HERRON ISLAND FERRY TERMINAL DOLPHIN REPLACEMENT

ADDENDUM NUMBER 1

January 30, 2017

TYPICAL ELEVATION

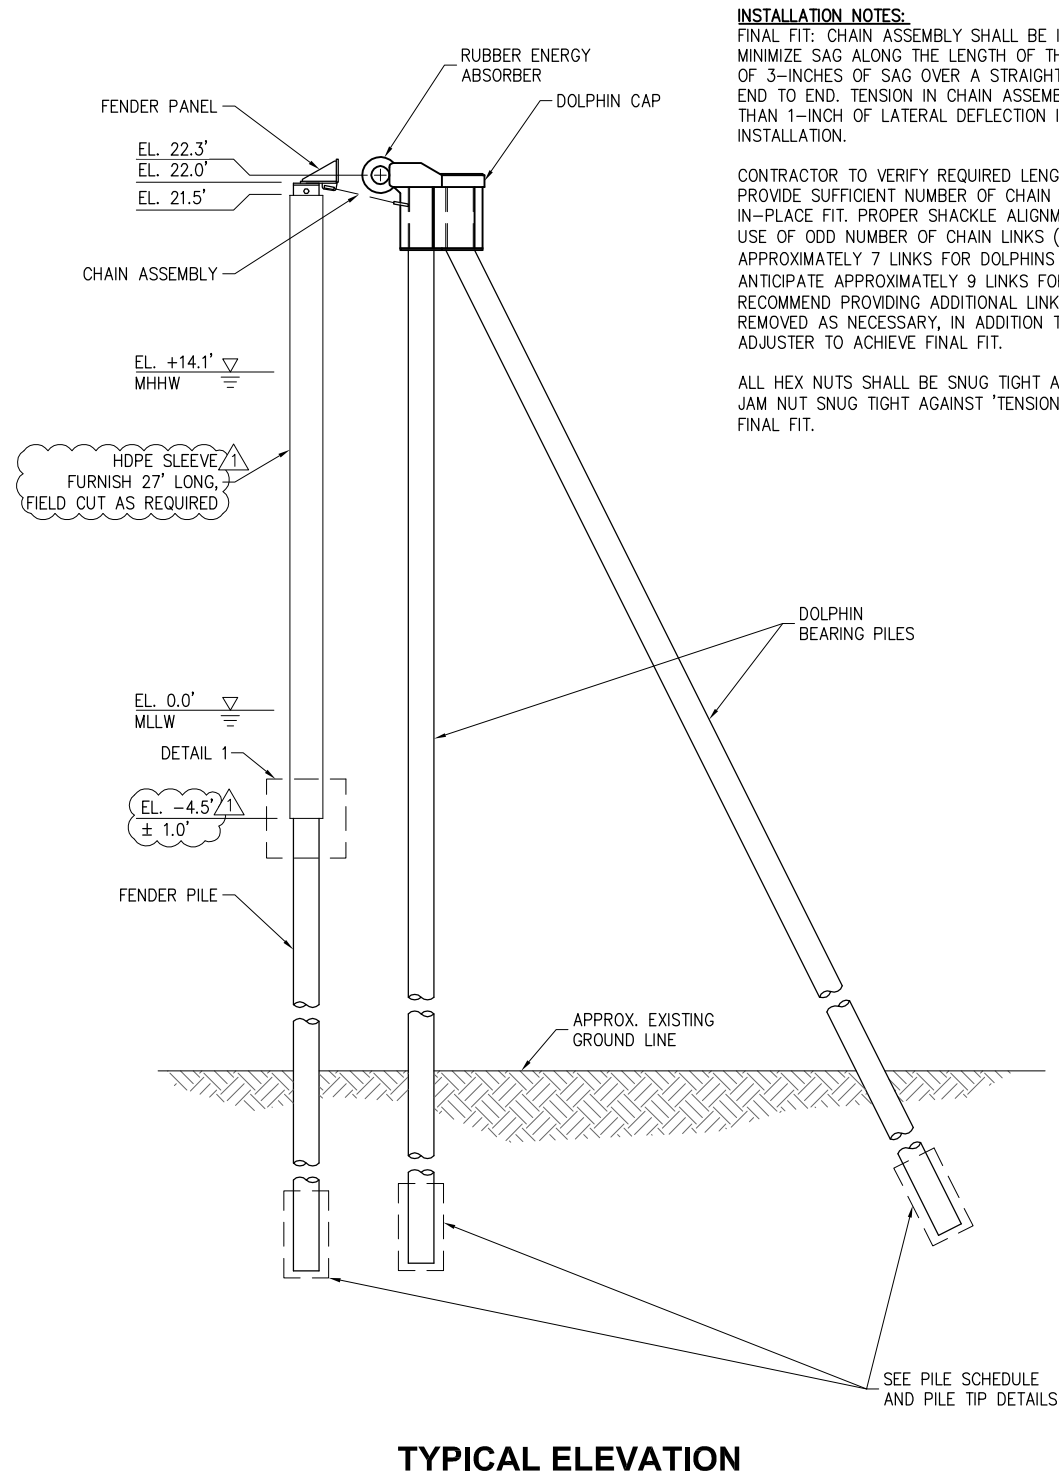
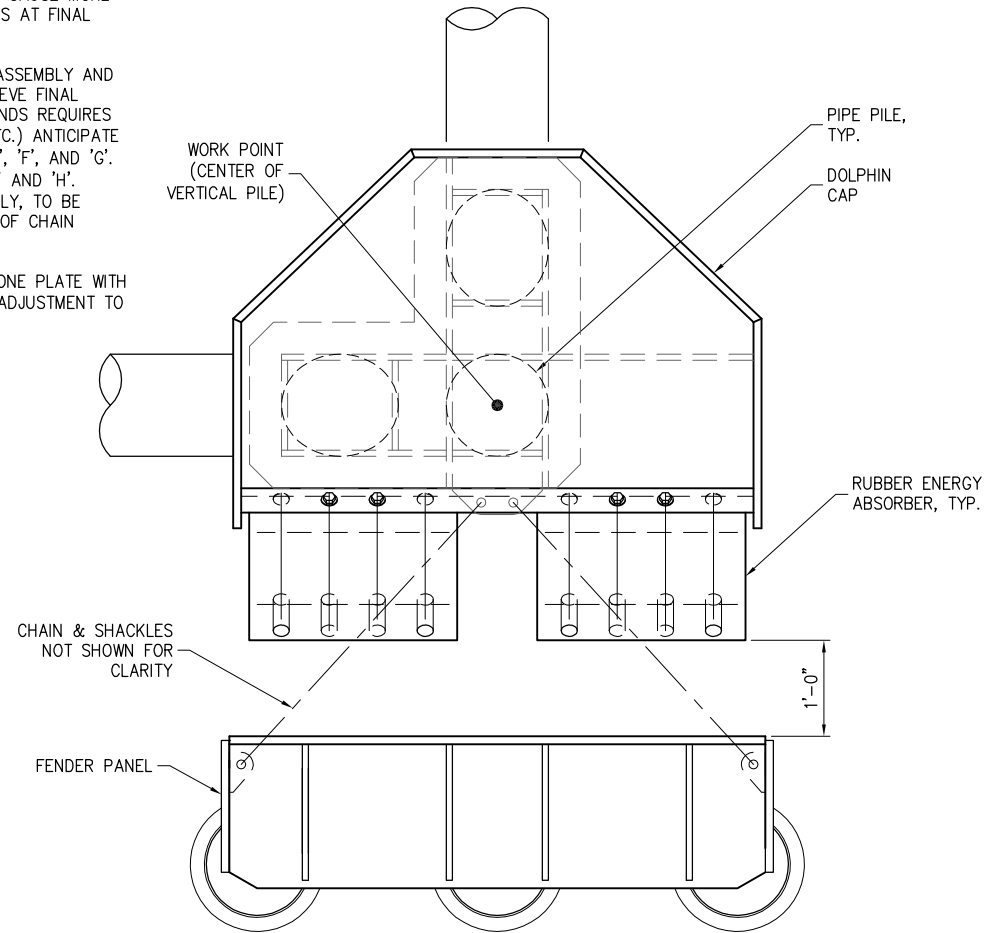
Sheet No. 9 – Dolphin Plan and Details	<p>Replace sheet 9 with Revision 1 sheet 9.</p> <p>Changes made to Typical Elevation to provide elevation tolerance for HDPE sleeves on fender piles.</p>
--	---

DOLPHIN CAP

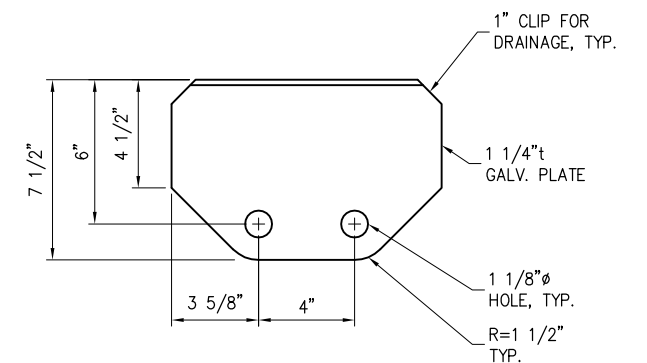
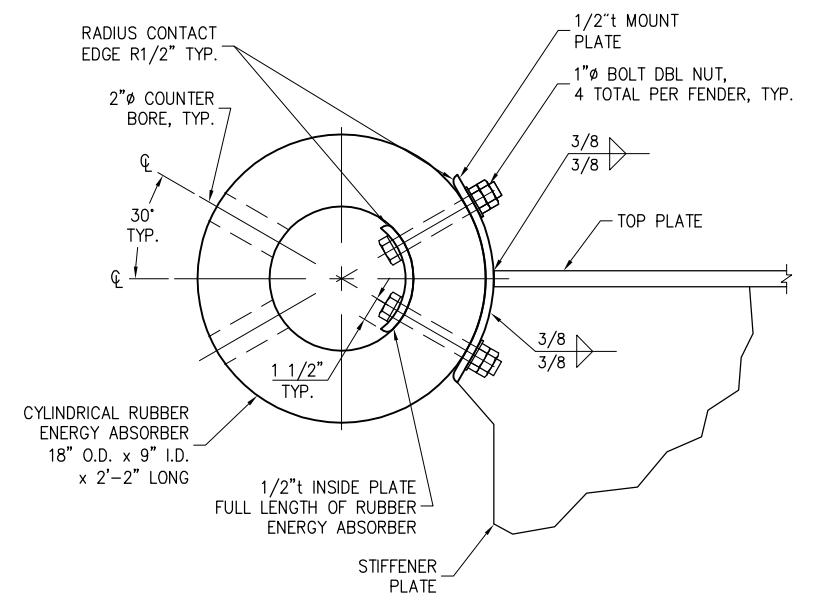
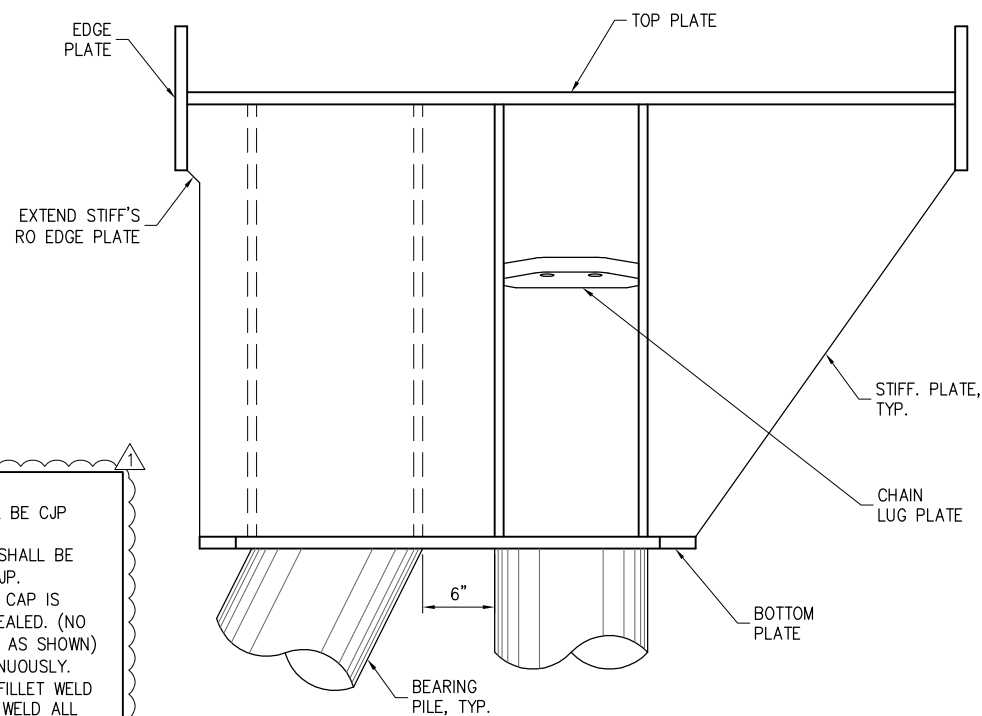
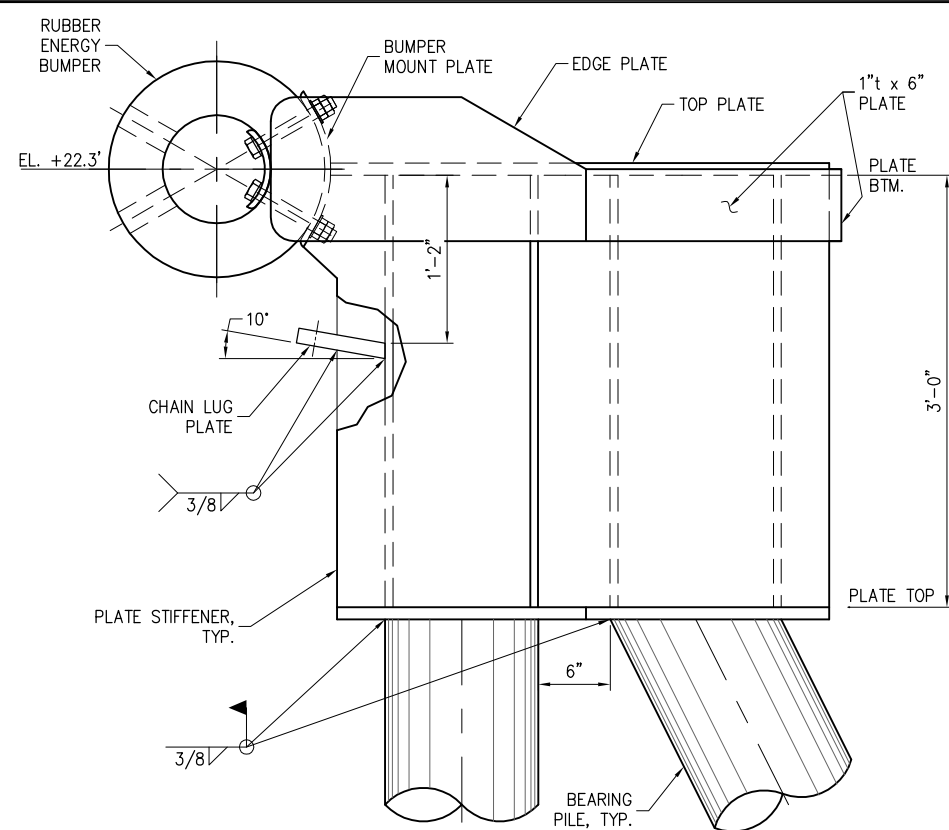
Sheet No. 10 – Dolphin Cap	Replace sheet 10 with Revision 1 sheet 10. Added weld notes to provide additional direction on required welds for assembly of dolphin cap.

- 1) ALL JOINTS TO BOTTOM PLATE SHALL BE CJP UNLESS NOTED OTHERWISE.
- 2) ALL OTHER WELDS IN THE PILE CAP SHALL BE 5/16" FILLET BOTH SIDES OR 1/2" PJP.
- 3) IN ALL CASES THE EXTERIOR OF THE CAP IS WELDED. WELDS ARE TOTALLY SEALED. (NO RAT HOLES OR DRAIN HOLES EXCEPT AS SHOWN)
- 4) ALL JOINTS SHALL BE WELDED CONTINUOUSLY.
- 5) ALL OTHER JOINTS SHALL BE 5/16" FILLET WELD ALL AROUND, OR EQUIVALENT BEVEL WELD ALL AROUND, UNLESS OTHERWISE NOTED.

FENDER
SUPPORT PLATES

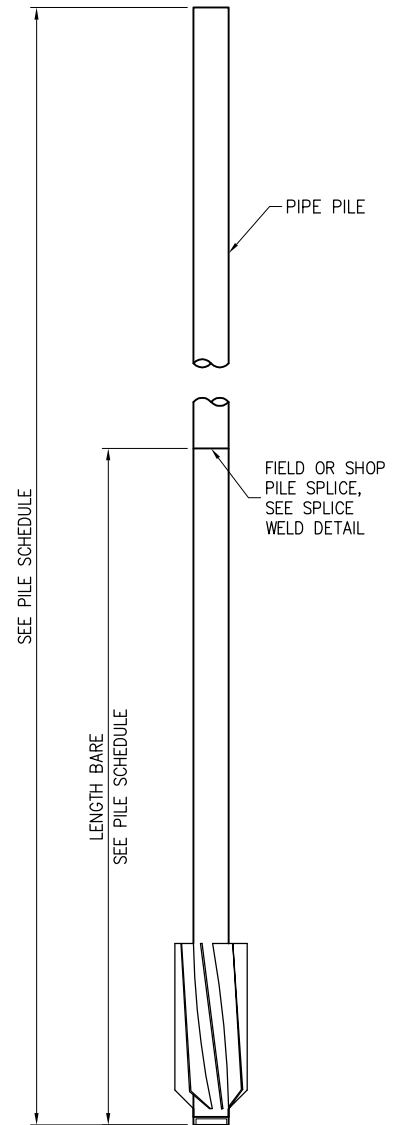
Sheet No. 14 – Pile Details	Replace sheet 14 with Revision 1 sheet 14. Changed fender support plate welds to field weld installation to allow better tolerance for elevation of HDPE sleeves on fender piles.
